**APPEAL TO
PLANNING COMMISSION
PARKLAND REQUIREMENT
REVIEW SHEET**

CASE NUMBER: SP-2019-0600C **Parks Board:** January 26, 2021
Planning Commission: February 9, 2021 postponed
March 9, 2021, postponed
March 23, 2021

CASE NAME: Wilder

ADDRESS: 4802 South Congress Avenue

WILDER DEVELOPMENT Parkland Concept

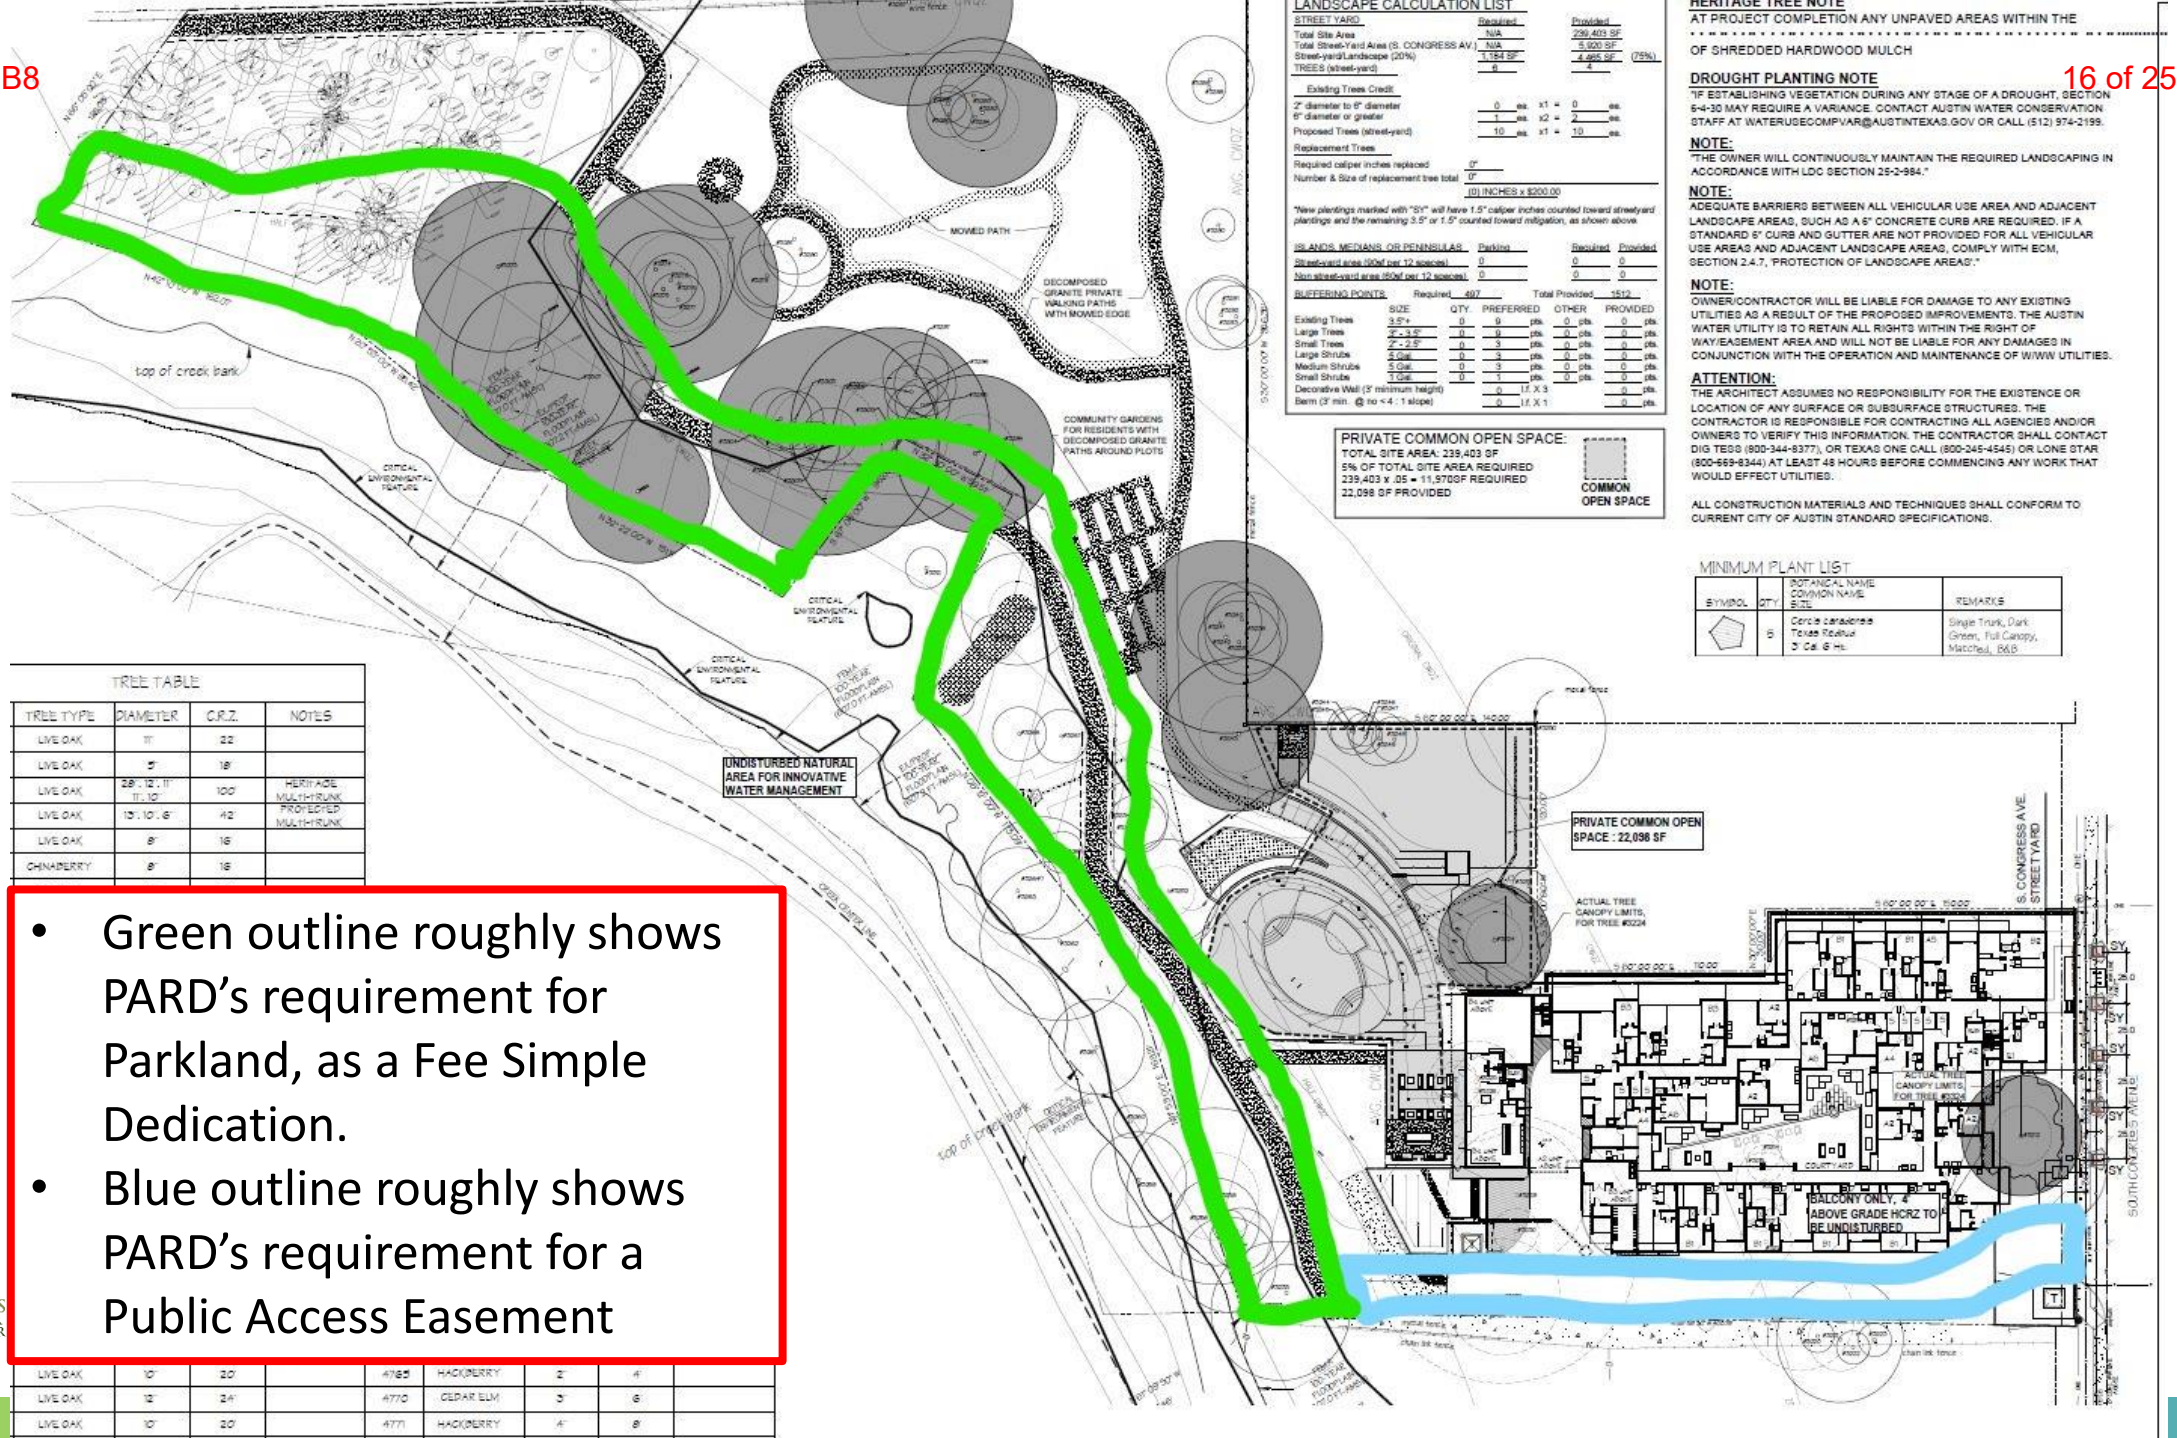
- Green outline roughly shows PARD's requirement for Parkland, as a Fee Simple Dedication.
- Blue outline roughly shows PARD's requirement for a Public Access Easement
